**ADDENDUM NO. 5**  
**04/7/2026**

**New Comfort Station**  
**Springfield Recreation Area**  
**Bon Homme County, SD**  
**Project No. Spri26Pa**

Owner: State of South Dakota  
Department of Game, Fish and Parks

# FLOOR PLAN

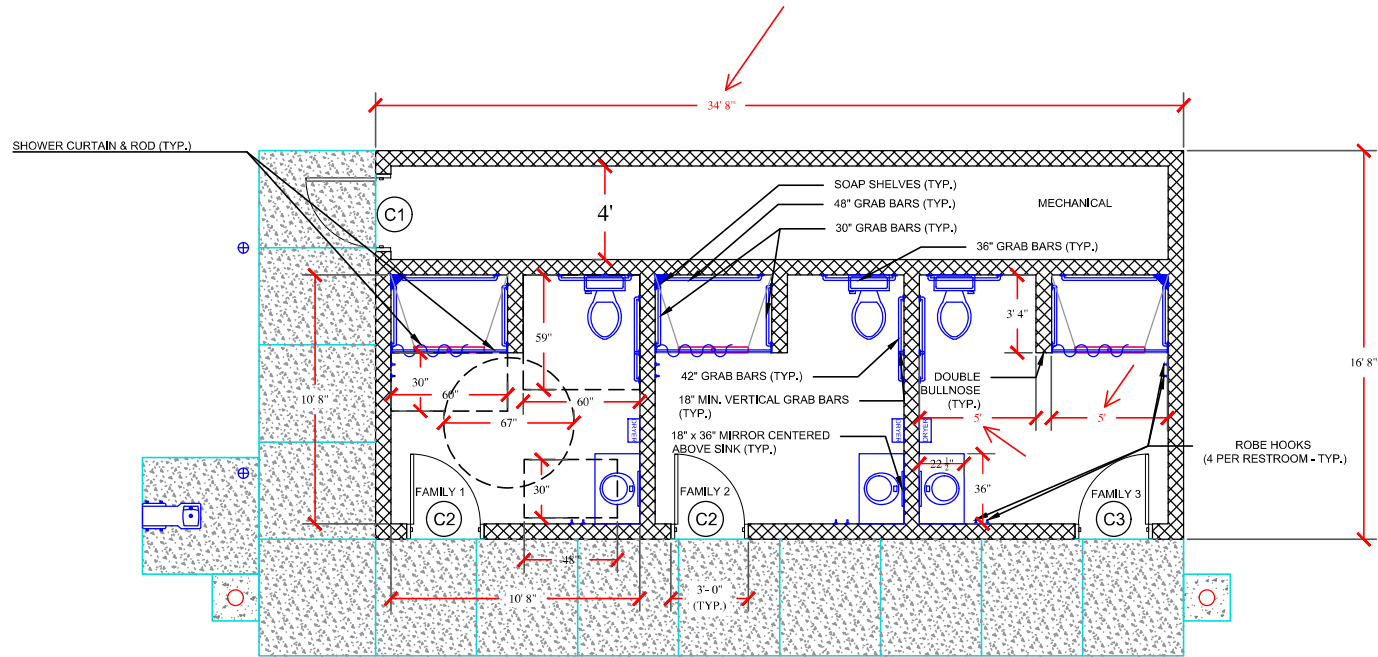
- **Item 1:** Corrects plan drawing dimension line errors made during Addendum #2.
  - Sheet 7 of 21 will be replaced from Addendum #2 with the attached plan sheet that shows the dimensions connecting to the correct points. (Corrected dimension lines shown with red text and arrows.)
